CLIENT DOCUMENT/DRAWING NO.:	0775-ENV-GEN-90-004	REV:	R02
VALMEC DOCUMENT NO.:	4017-PLA-HS-009	REV:	2
SUBCONTRACTOR DOCUMENT NO.:		REV:	
DOCUMENT/DRAWING TITLE:	BROKEN HILL BESS PROJECT BATTERY STORAGE FACILITY HERITAGE MANAGEMENT PLAN

Broken Hill BESS: Battery Storage Facility (Stage 1) Heritage
Management Plan

Project Name	Broken Hill BESS: Battery Storage Facility (Stage 1) Heritage Management Plan
Project Number	22COF2207
Project Manager	Matthew Finlayson
Prepared by	Mathew Finlayson
Reviewed by	Tim Hill
Approved by	Tim Hill
Status	Final
Version Number	V2d
Last saved on	5 August 2022

Appendix 3: Cultural Heritage Constraints (AECOM 2022)

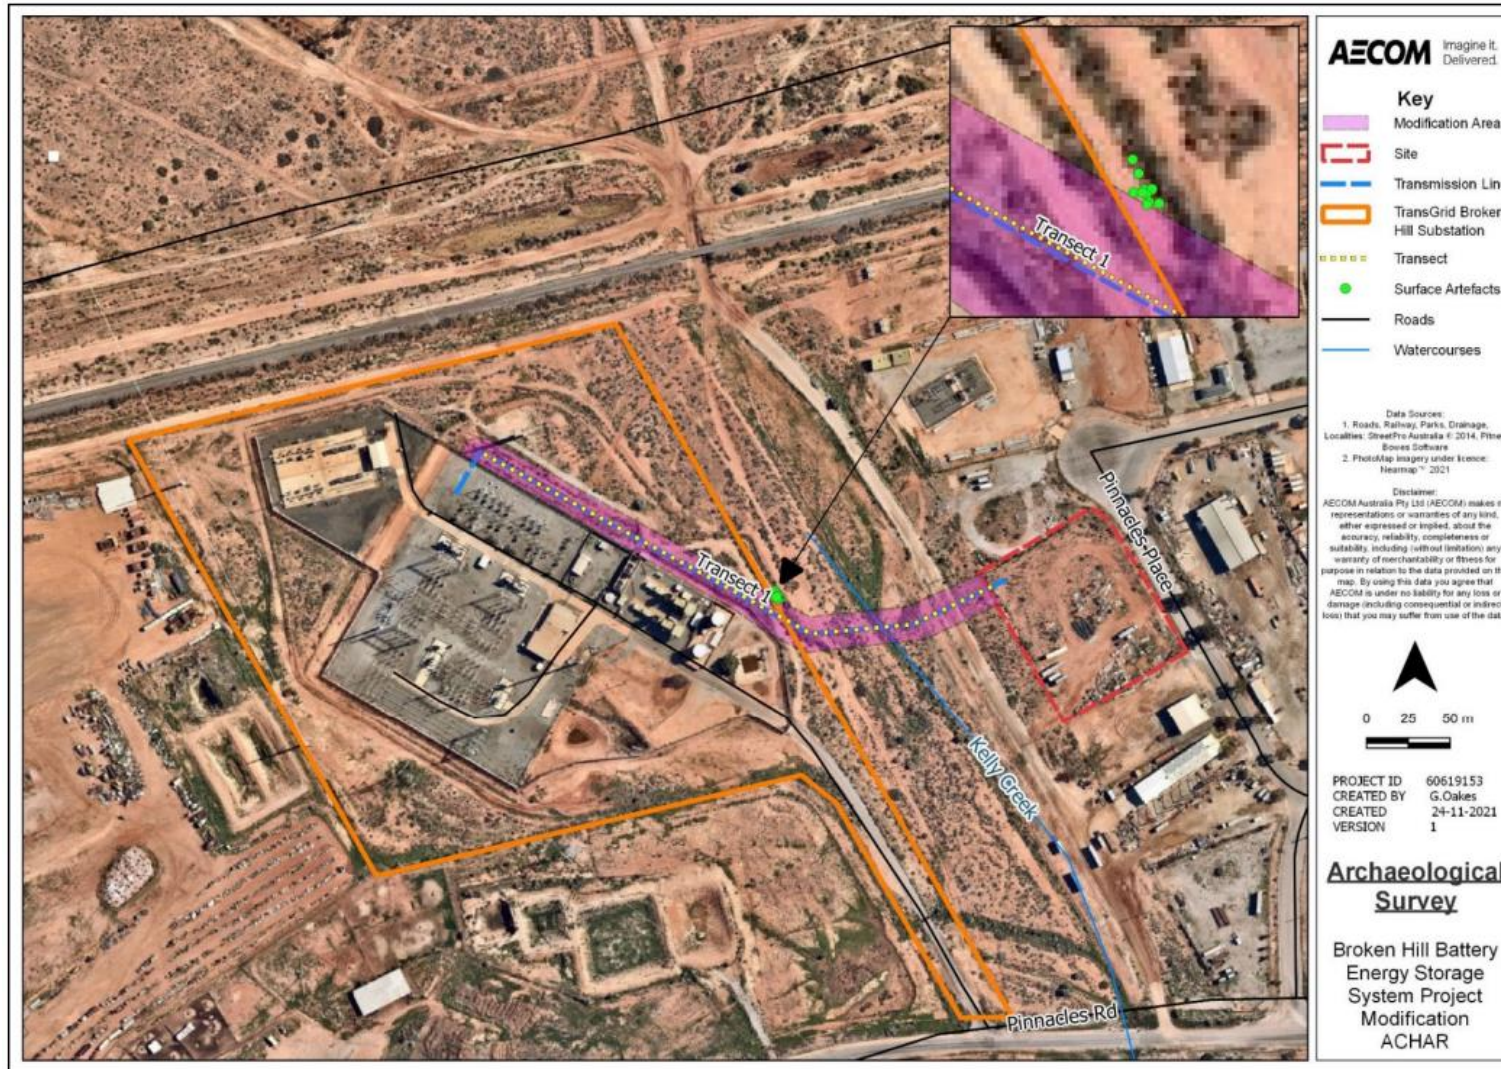
1. 2.2 Plan Development – 4 RAPs but consultation with 3 only (Cally Doyle not included) ?
2. 2.3.2 High Voltage Power Easement – Avoidance, no specific mgt measures provided in AHMP. Please ensure site is mapped in CEMP (or similar), exclusion fencing (if appropriate with RAPs) and included in inductions (& tool box meetings) as an exclusion zone.
